# Access Compliance Report

## Public Rights-of-Way

### (Pedestrian Signals)

Intersection ID: N/A	Main Street:	Cross Street: N/A	Location: N/A
ADA ID: 113D3BECBE84	Signal Type: One Push Button-Non APS	Overall Compliance: No	Severity Score: BTN 1: N/A BTN 2: N/A No BTN: N/A
Codes/Mitigation Info/Possible Solution		Field Measurements/Component Compliance

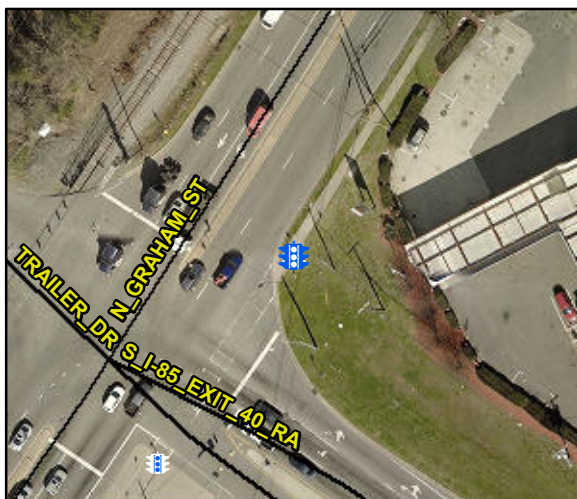
Surveyor Notes: TEXT HT 5/16

PROW/ADA: R410.6, TMUTCD 4e.08, R404.2, R404.3, R406.2, R404.7.3

Compliance	Description	Data	Compliance	Description	Data
	Button Count	Button1	N/A	Distant to Additional Button (in)	N/A
	Additional Button Present?	No		Additional Button ID	N/A
N/A	Signal Buttons Required?	N/A	N/A	Additional Ped Posts Required	N/A
	How Many Ped Street Xings?	1		Located In An Island/Median?	No
N/A	B 1 Sign Present?	Yes	N/A	B 2 Sign Present?	N/A
Yes	B 1 Sign Purpose?	Yes	N/A	B 2 Sign Purpose?	N/A
No	B 1 Sign Lettering & Contrast?	No	N/A	B 2 Sign Lettering & Contrast?	N/A
Yes	B 1 Parallel To XWalk?	Yes	N/A	B 2 Parallel To XWalk?	N/A
Yes	B 1 PAR to Button?	Yes	N/A	B 2 PAR to Button?	N/A
Yes	B 1 PAR to XWalk?	Yes	N/A	B 2 PAR to XWalk?	N/A
Yes	B 1 Clear Floor Space?	Yes	N/A	B 2 Clear Floor Space?	N/A
N/A	B 1 FWD Approach?	Yes	N/A	B 2 FWD Approach?	N/A
N/A	B 1 FWD Approach Constrained?	No	N/A	B 2 FWD Approach Constrained?	N/A
No	B 1 FWD Approach Reach (in)	18.0	N/A	B 2 FWD Approach Reach (in)	N/A

N/A	B 1 FWD Approach Width (in)	N/A	N/A	B 2 FWD Approach Width (in)	N/A
N/A	B 1 FWD Approach Obstruction?	Yes	N/A	B 2 FWD Approach Obstruction?	N/A
N/A	B 1 FWD Approach Obstruction Dist (in)	18.0	N/A	B 2 FWD Approach ObstructionDist (in)	N/A
N/A	B 1 PARA Approach?	Yes	N/A	B 2 PARA Approach?	N/A
N/A	B 1 PARA Approach Constrained?	No	N/A	B 2 PARA Approach Constrained?	N/A
No	B 1 PARA Approach Reach (in)	18.0	N/A	B 2 PARA Approach Reach (in)	N/A
N/A	B 1 PARA Approach Width (in)	N/A	N/A	B 2 PARA Approach Width (in)	N/A
N/A	B 1 PARA Approach Obstruction?	Yes	N/A	B 2 PARA Approach Obstruction?	N/A
N/A	B 1 PARA Approach Obstruction Dist (in)	18.0	N/A	B 2 PARA Approach ObstructionDist (in)	N/A
No	B 1 Clear Floor Space Slope (%)	5.3	N/A	B 2 Clear Floor Space Slope (%)	N/A
Yes	B 1 Clear Floor Space XSlope (%)	0.3	N/A	B 2 Clear Floor Space XSlope (%)	N/A
N/A	B 1 PAR Slope (%)	0.2	N/A	B 2 PAR Slope (%)	N/A
Yes	B 1 Height (in)	39.0	N/A	B 2 Height (in)	N/A

Yes	B 1 Clear Xing Direction?	ClearlyMarked	N/A	B 2 Clear Xing Direction?	N/A
	B 1 Crossing Direction	To SW		B 2 Crossing Direction	N/A
Yes	B 1 DistanceTo XWalk (in)	0.0	N/A	B 2 DistanceTo XWalk (in)	N/A
No	B 1 DistanceTo Curb (in)	124.0	N/A	B 2 DistanceTo Curb (in)	N/A
Yes	B 1 Diameter (in)	2.0	N/A	B 2 Diameter (in)	N/A

Possible Solutions: Replace Signal Push Button With APS Button on New Post. Remove & Replace Sign.
